Responses to Review Questions

NSF Review of Advanced LIGO

12 June 2003

Recovery scenario

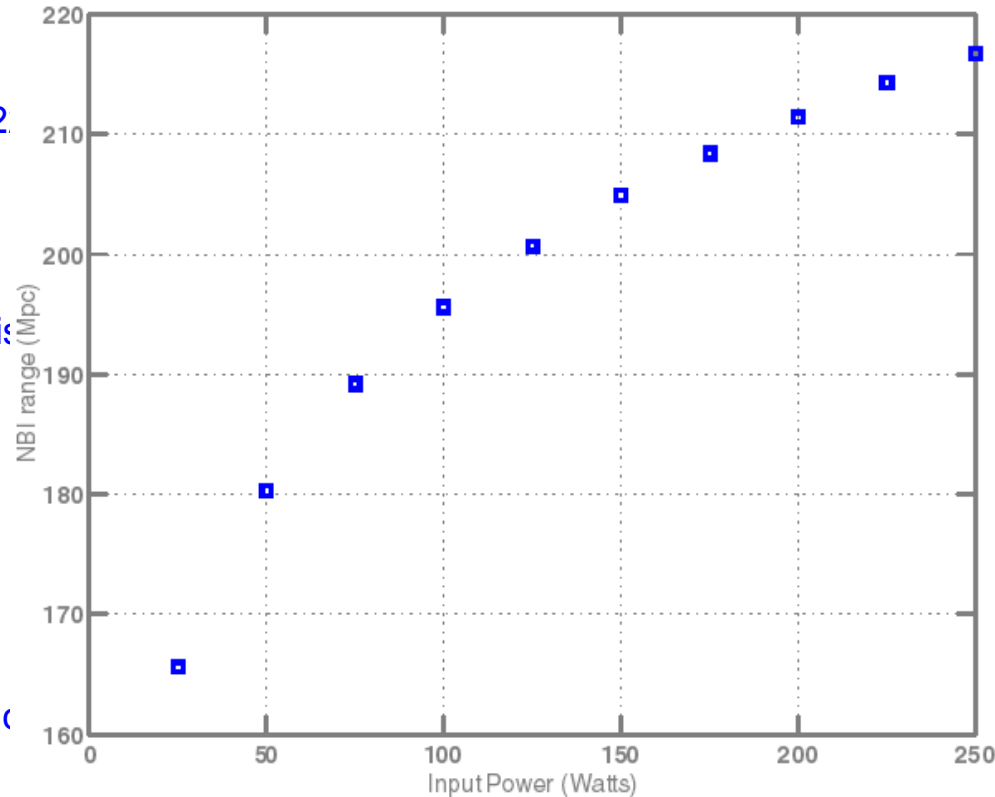
- Suppose no improvement in coatings found before coatings must be applied (in ~2006), BUT then a better coating is developed at a later time (e.g., 2010)
- Spares for test masses would be coated with improved coating; sufficient spares exist to replace all masses in one interferometer
- Old coated masses swapped out for new coated masses
 - » Opening vacuum, but minor activity – down time of ~1 month
- Old coated masses repolished, coated, installed in second ifo
 - » ~6 month turnaround
- Process repeated for third interferometer
- ...gradual upgrade of all interferometers over ~1.5 years, minimal down time (~3 months out of ~18 months), cost ~\$2M

Effect of lower laser power

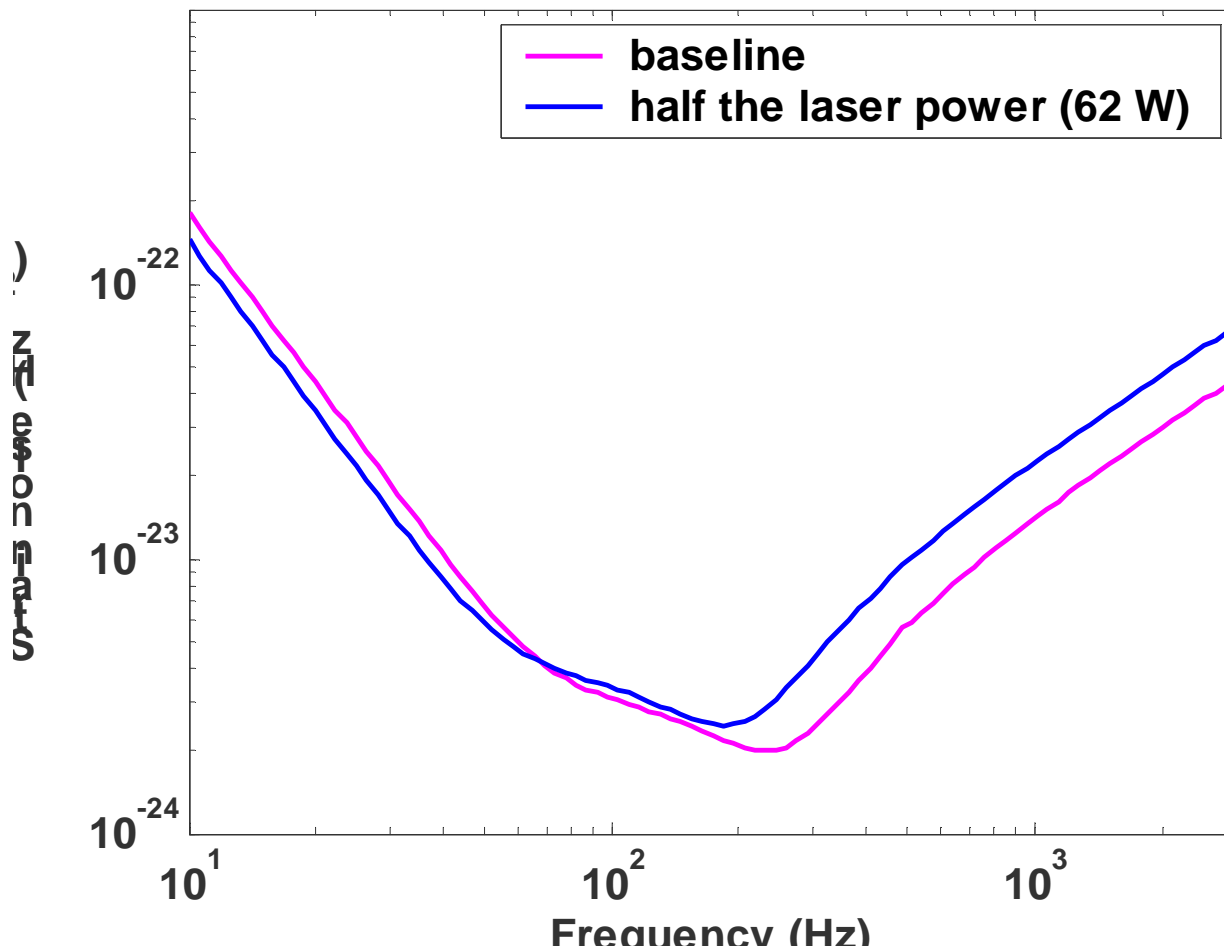
- Laser power
 - » Plan calls for 180 watts
 - » If do not improve over present 87 W, 32 Mpc instead of 350 Mpc
- Laser intensity noise
 - » Plan calls for $2e-9 \Delta P/P$ (to make contribution 1/10 of other noises)
 - » If do not improve over present $1e-8$, noise level increases by 1.11 in amplitude
- Modulators/Isolators
 - » Plan calls for handling 180 W
 - » If can only handle half power, 322 Mpc instead of 350 Mpc
- Sapphire absorption
 - » Plan calls for 40 ppm/cm, irregularities 'moderate'
 - » If do not improve over present average of 60 ppm, reduce input power to $(40/60)$, 332 Mpc
 - » If do not improve over present irregularity of pk-pk ~ 130 ppm and spatial scales of ~ 0.5 cm, guess 10% power loss, or ~ 340 Mpc

- Impact of reduced laser power or sapphire absorption losses

Effect of coating loss, sapphire baseline

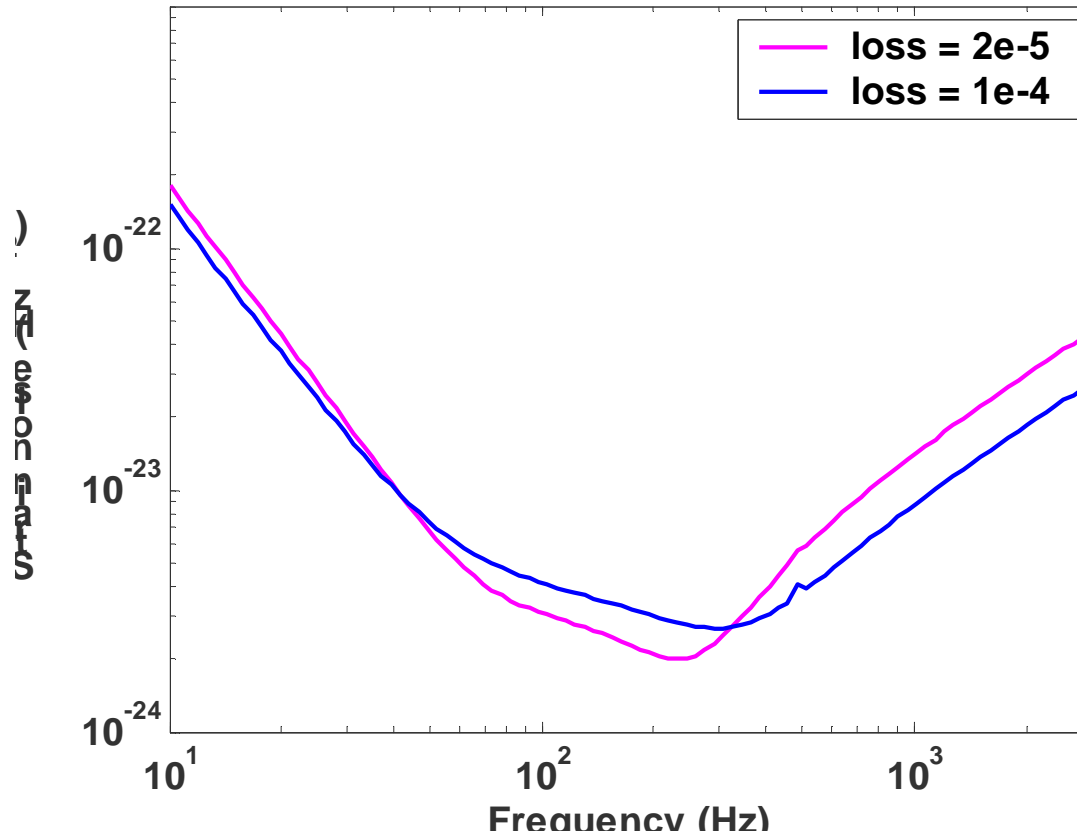
- Coatings

- » Plan calls for losses of $\sim 2e-5$ phi on sapphire
- » If do not improve over present best $1e-4$ phi, 314 Mpc
